Intel[®] 865G/865GV Chipset

Specification Update

Intel[®] 82865G/82865GV Graphics Memory Controller Hub (GMCH)

January 2004

1. Package Dimensions (Bottom View)

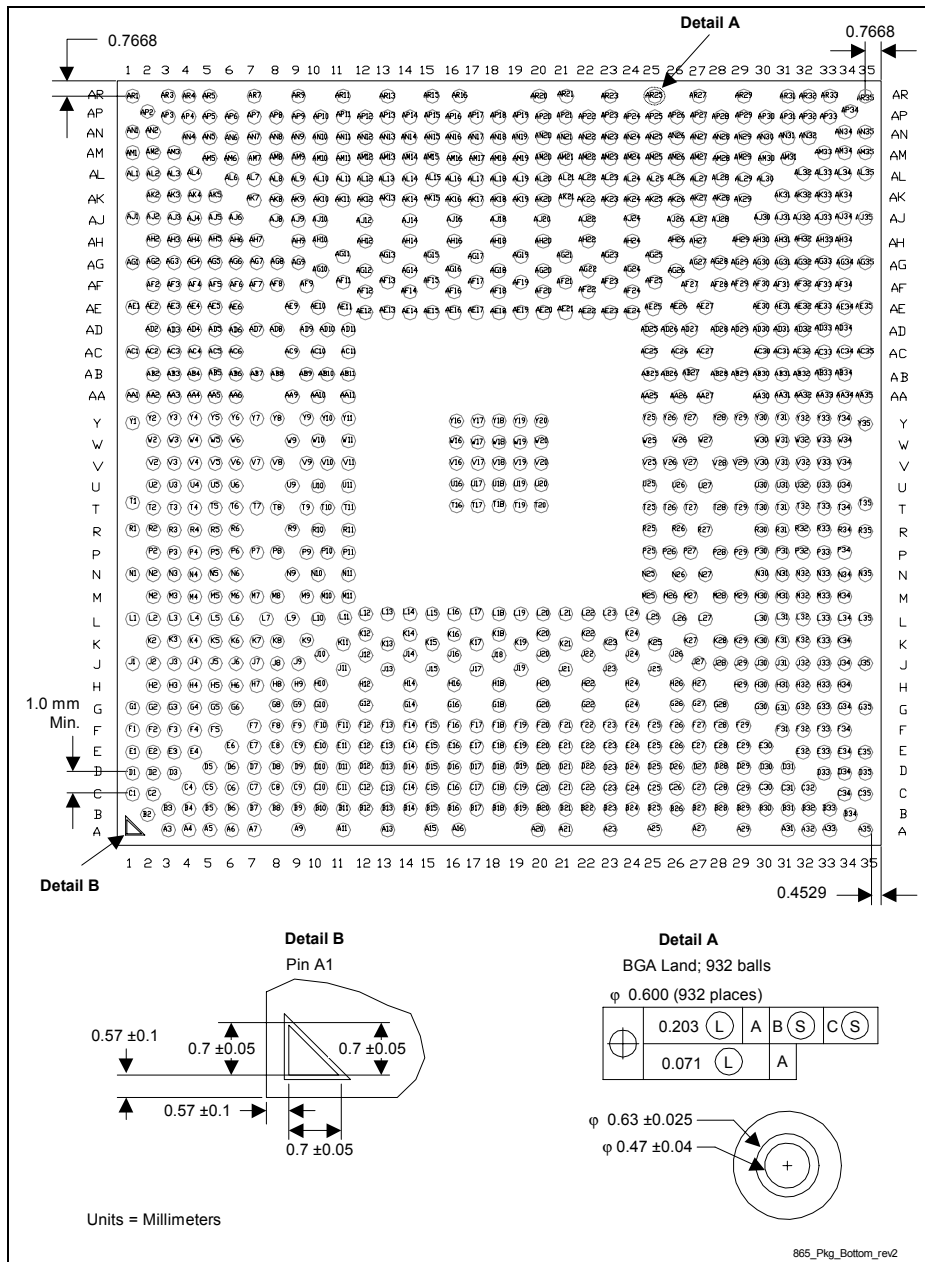
Figure 19, “Intel® 82865G GMCH Package Dimensions (Bottom View)” is replaced with the following, corrected figure:
